CITY OF MURFREESBORO PLANNING COMMISSION AGENDA

March 16, 2016
1:00 PM

**MURFREESBORO PLANNING COMMISSION
STAFF COMMENTS, PAGE 1
MARCH 16, 2016**

13th CIVIL DISTRICT - RUTHERFORD COUNTY - TN
 DATE: FEBRUARY, 2016 SCALE 1"=30' SH. 2 OF 2

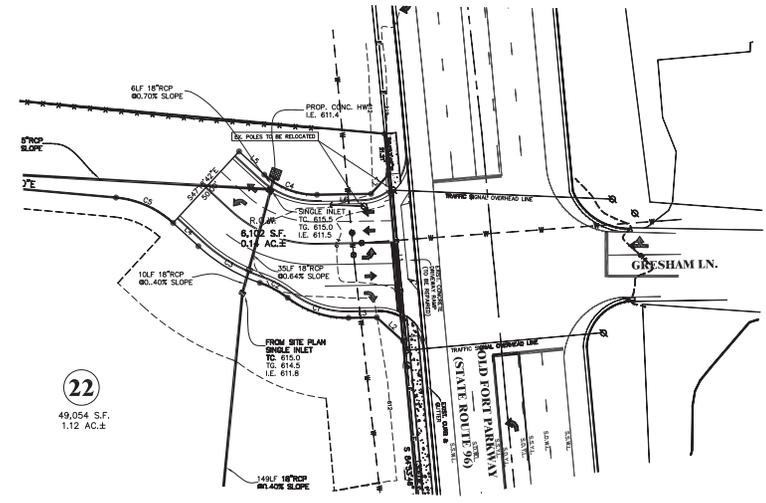
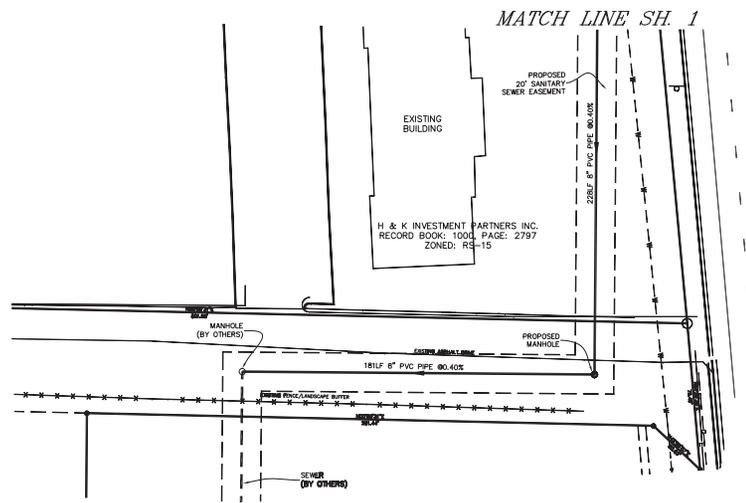
- 1) Remove the proposed lot line for lot 23 that cuts off the finger from the remainder of the lot.
- 2) Show and label the front MBSL on Lot 23. Because Lot 23 is a flag lot, the 42' MBSL is along the north property line.

- 5) A TDOT ROW permit will be required for the new entrance off Old Fort Pkwy/ State Route 96.
- 6) Construction plans for roadway improvements will require the review and approval of the City Engineer.

- 7) Remove the note regarding rain garden.
- 8) Provide a note that stormwater will be reviewed at the site plan level.
- 9) Provide a copy of the NPDES Notice of Coverage or Notice of Intent to the office of the City Engineer. Discharges of stormwater associated construction activities on sites that disturb one acre or more and including sites less than 1 acre that are part of a larger common plan of development or sale will require a NPDES Tennessee Construction General Permit.

REVISED:	
DRAWN: SLA	
DATE: 2-25-16	
CHECKED:	
MAT:	
FILE NAME:	
1400-project	
SCALE:	1" = 50'
JOB NO.:	14400
SHEET:	5 of 11

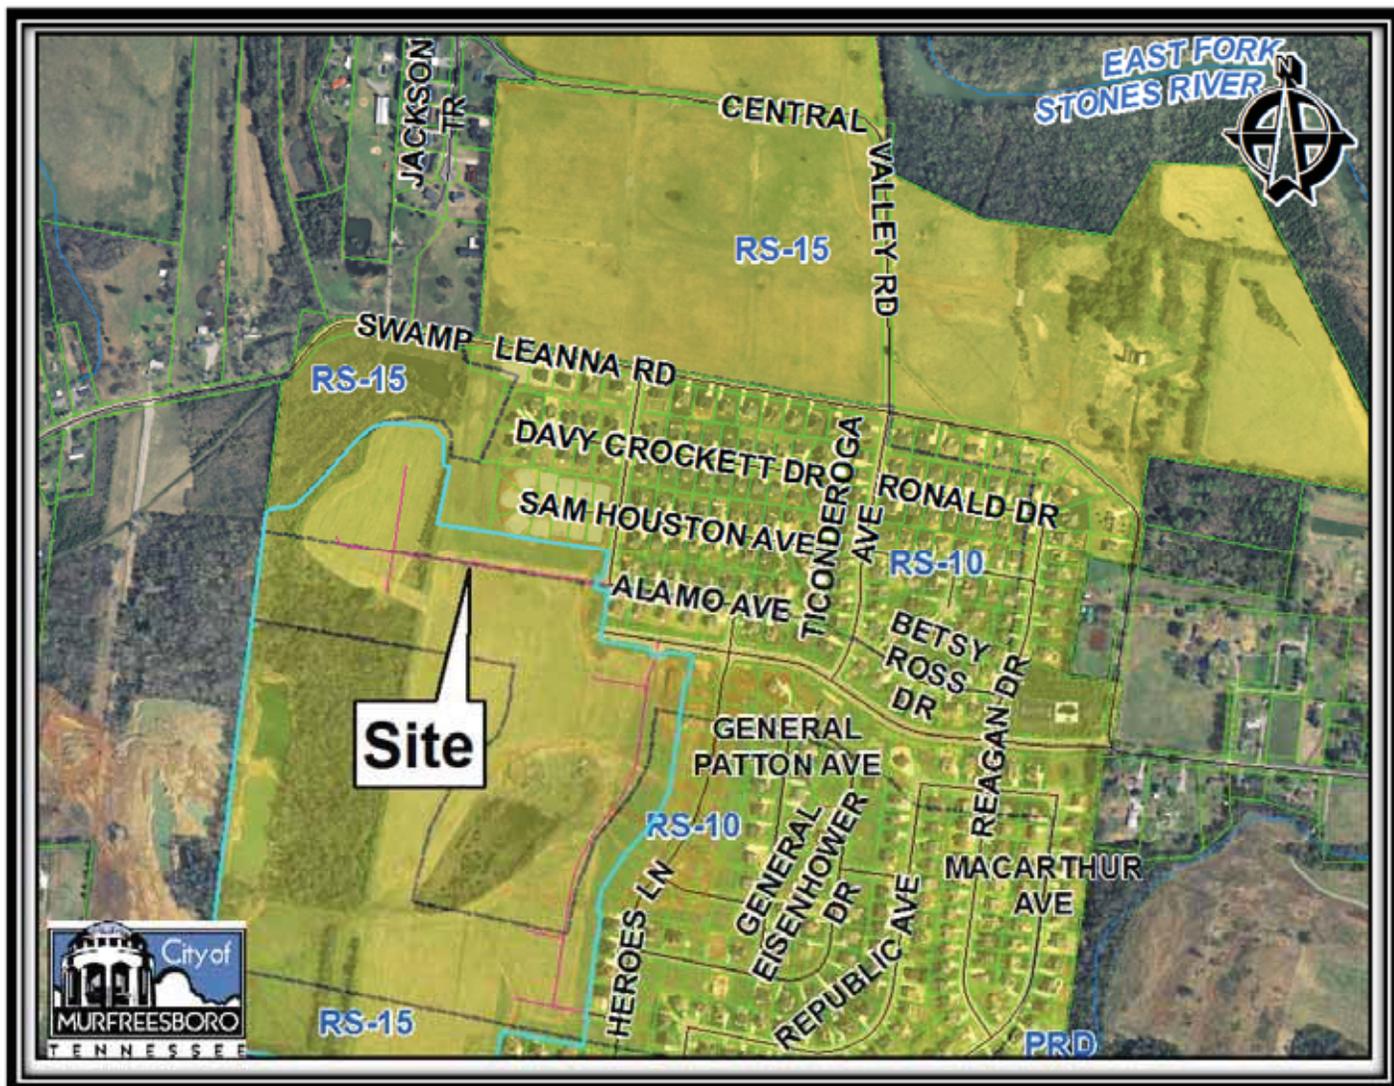
- 1) Staff questions whether Lot 71 meets the minimum lot size for this section of 15,000 (111 x 135 = 14,985). Verify that lot 71 is 15,000 sqft.
- 2) Make the proposed lot lines bold on the drawing so that they stand out better.

- 5) Show roundabout signage including yield, roundabout and pedestrian crossing signs.
- 6) All street signage needs to be in place prior to the release of building permits.

- 1) Proposed Electric has not been approved by MED. Preliminary construction plans must be submitted to MED in digital AutoCAD and pdf format for the Electric design. Please email to jnguyen@medtn.com.

- 2) Show existing Electric.
- 3) Show approved MED conduit design and approved MED transformer pad location.
- 4) All fire hydrants must be located 4ft from nearest electric facility.

Site & Utility Plan

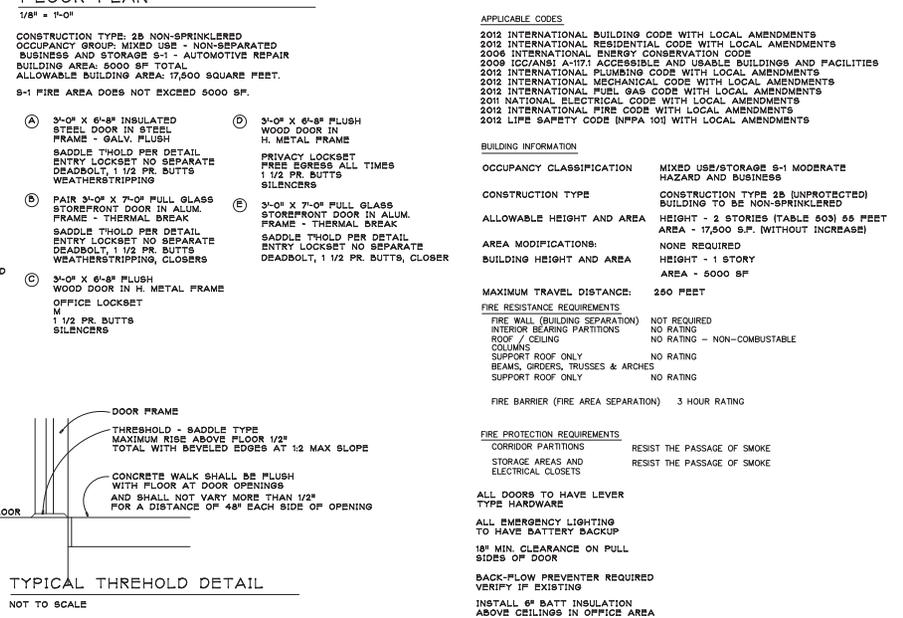
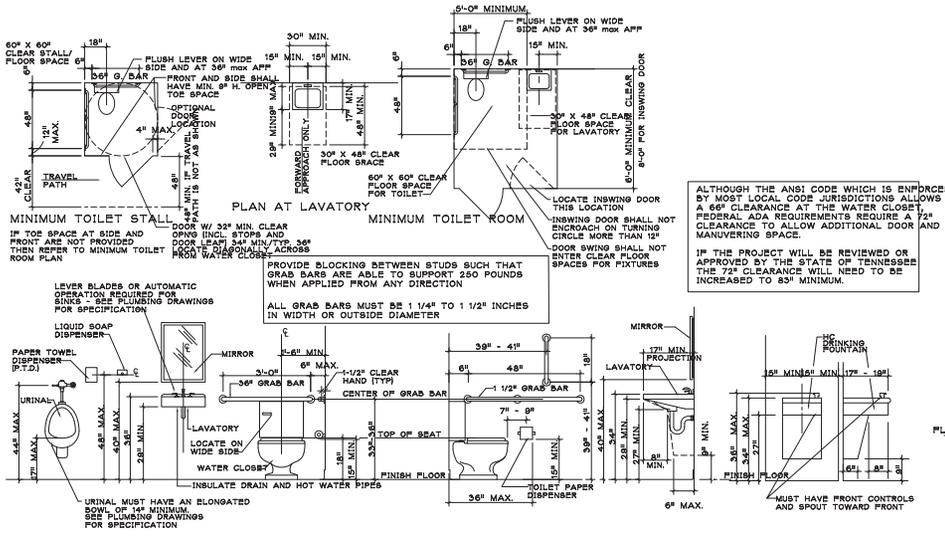
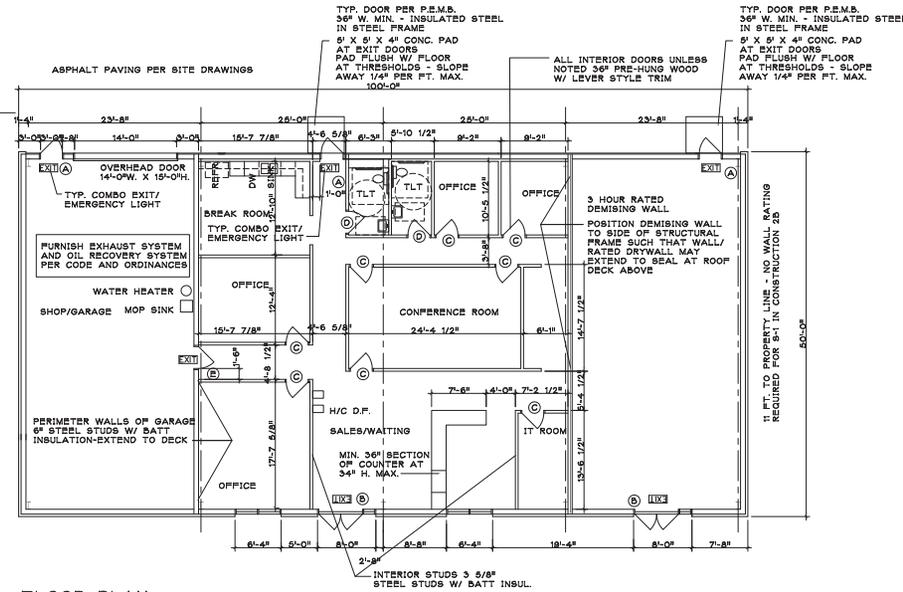
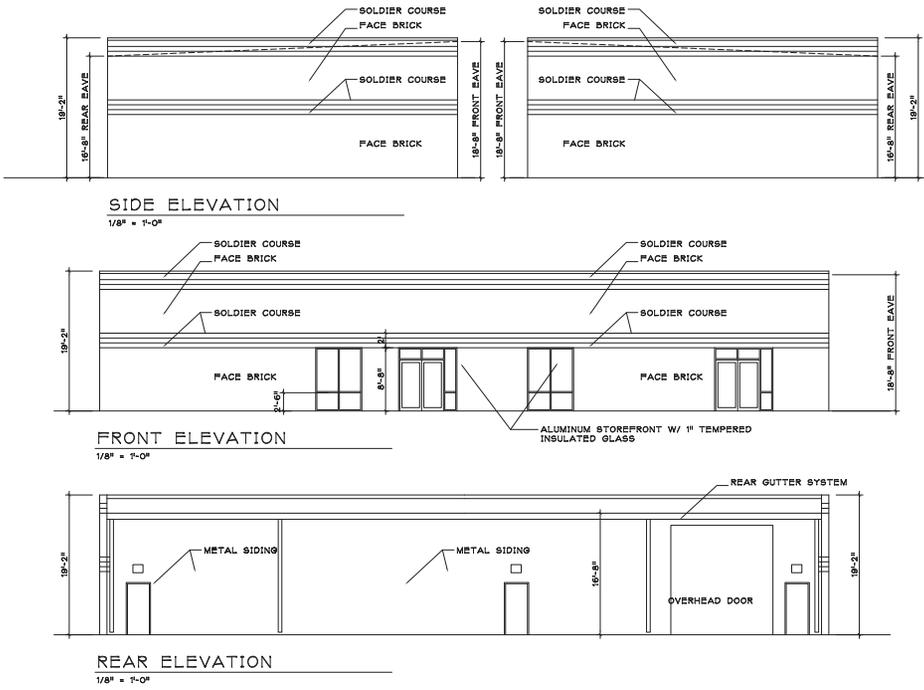
- 20) A final construction stormwater inspection certification, CN-1173 and/or Notice of Termination (NOT), CN-1175 ([http://www.tennessee.gov/environment/article/permit-water-
npdes-stormwater-construction-permit](http://www.tennessee.gov/environment/article/permit-water-npdes-stormwater-construction-permit)) will be required prior to certificate of occupancy (CO).
